129-17-CA

1804 HILLSBOROUGH STREET

ZM CAVENESS HOUSE (OX-3-GR)

Nature of Project:
Install privacy fence;
construct garden shed

Garden Shed
1804 Hillsborough St.

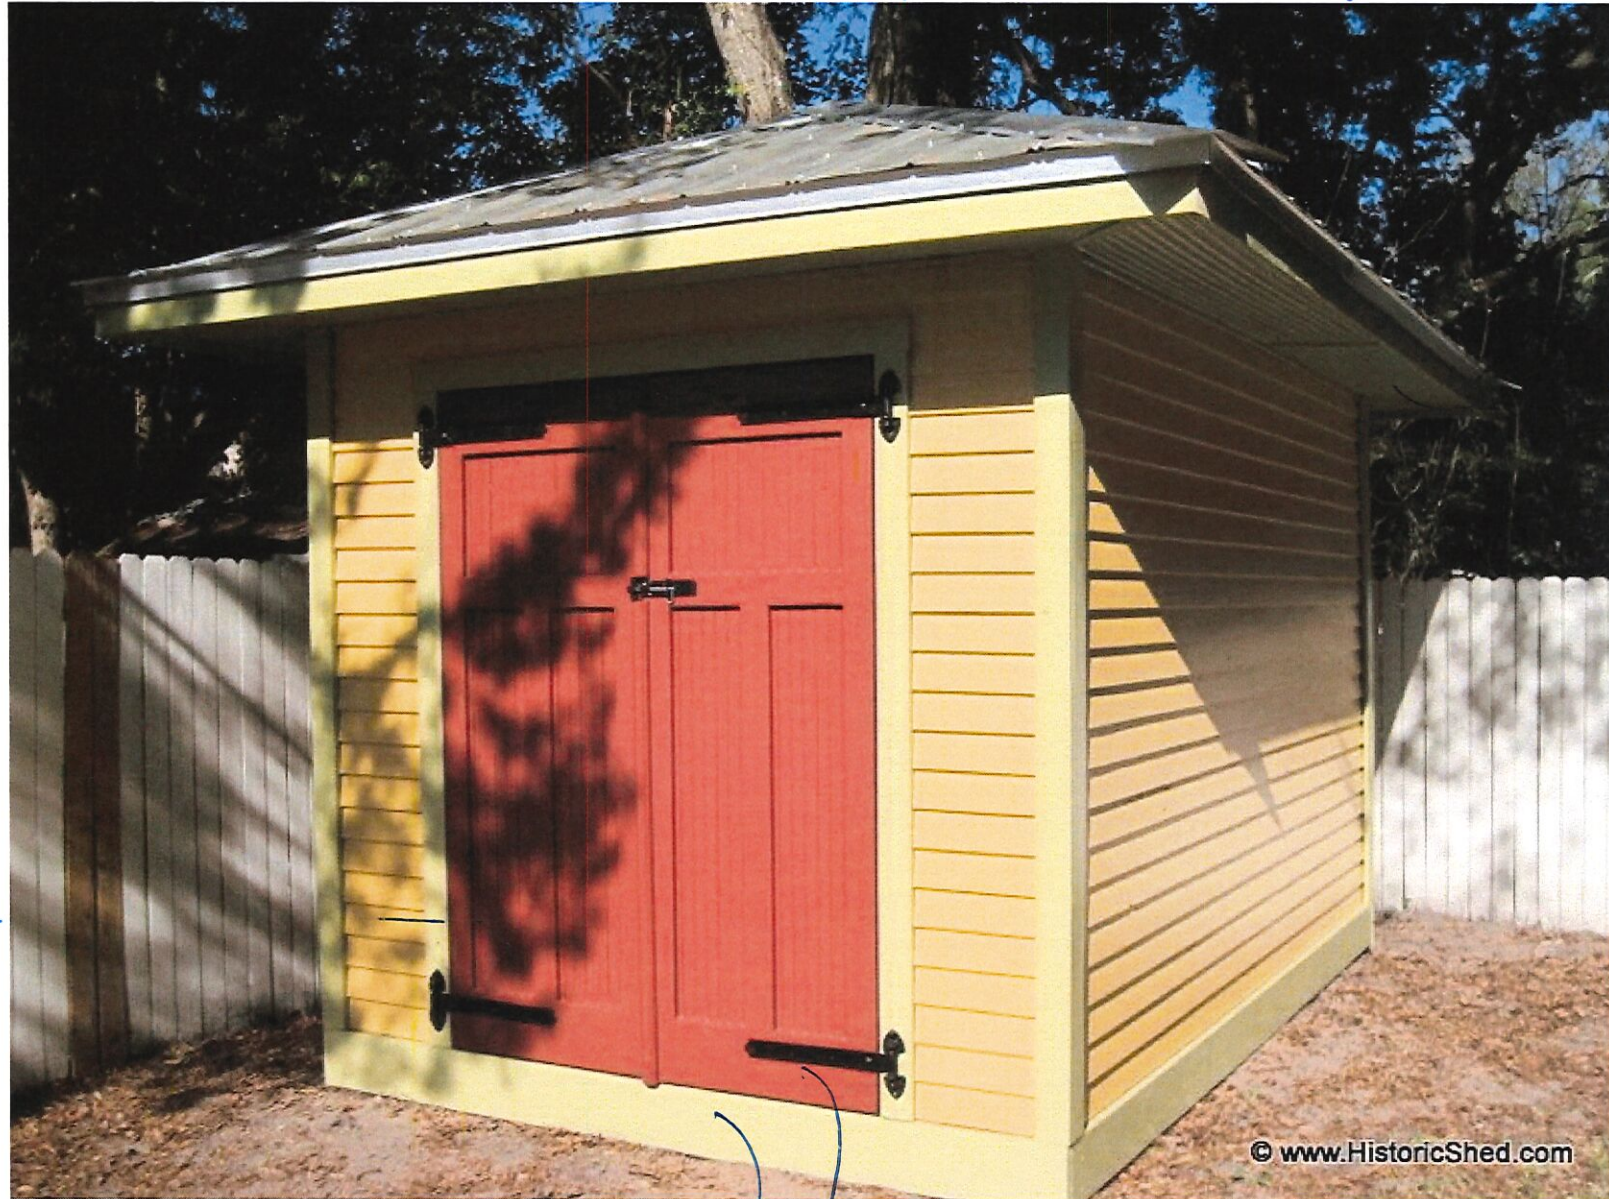
- 1* Accessory buildings up to 144 SF are approvable by staff as Minor Works.
- 2* The proposed shed sits adjacent the historic garage.
- 3* The shed is proposed to be wood with a hipped roof and colors to match the house and garage. A photographic example was provided. Details and specifications were not provided.

- 1. That the solid portion of the fence be a maximum of 6 feet in height and that the revised design be provided to and approved by staff prior to issuance of the blue placard.
- 2. The details and specifications for the shed be provided to and approved by staff prior to the issuance of the blue placard.

Fence transition layout:

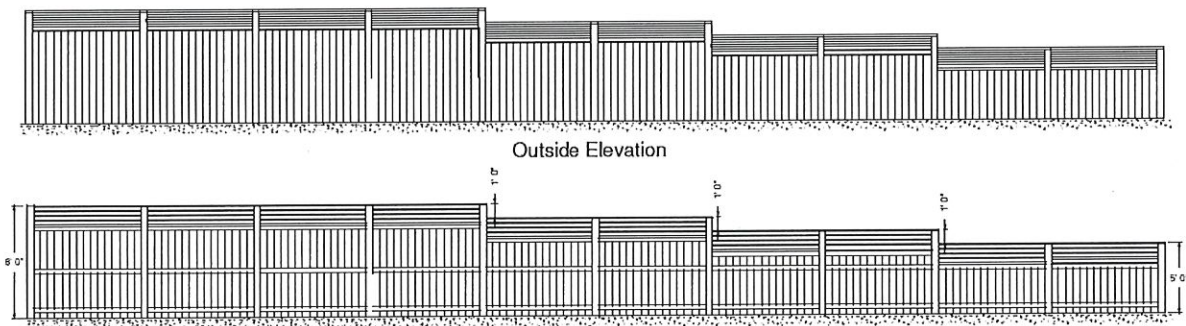
- 4* The fence ranges in height from 5 feet to 8 feet. The maximum height of fences typically approved is 6 feet.
- 5* The Craftsman design of the fence includes a partially open top portion of 1-1/2 feet. The solid portion ranges from 3-1/2 feet to 6-1/2 feet.
- 6* There is a 9 foot tall fence on an adjacent property across the alley which is neither a historic landmark nor in a historic district.

Fence Panel Design

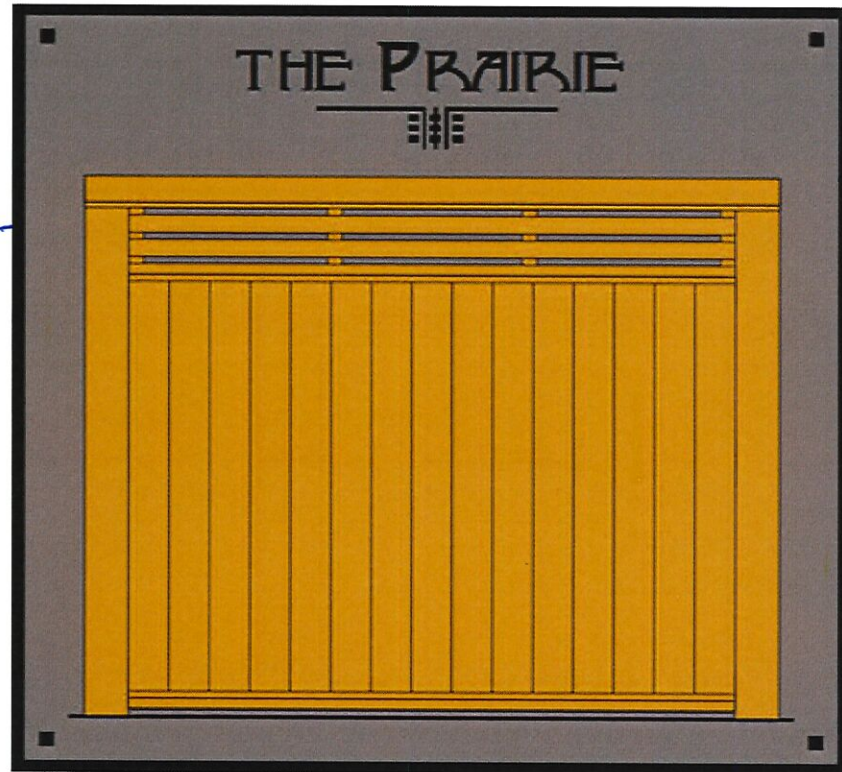
- 1* The landmark designation report states that the 2-story brick foursquare Dr. Z. M. Caveness House is architecturally significant as a well-preserved brick foursquare house with influences of the Prairie School of architects. The house is also significant as a surviving residential structure on a street which was once one of Raleigh's prime residential boulevards, but where today commercial encroachment is predominant. It is also historically significant for its association with Dr. Zebulon Marvin Caveness, a prominent physician and civic leader in Raleigh for over forty years.
- 2* The Maple tree will be kept inside the fence and protected from harm by manually digging around the roots. If needed, the location of the fence panels will be adjusted to locate the posts away from the roots.
- 3* The wood fence is proposed to be along the property line as it typical of fences.
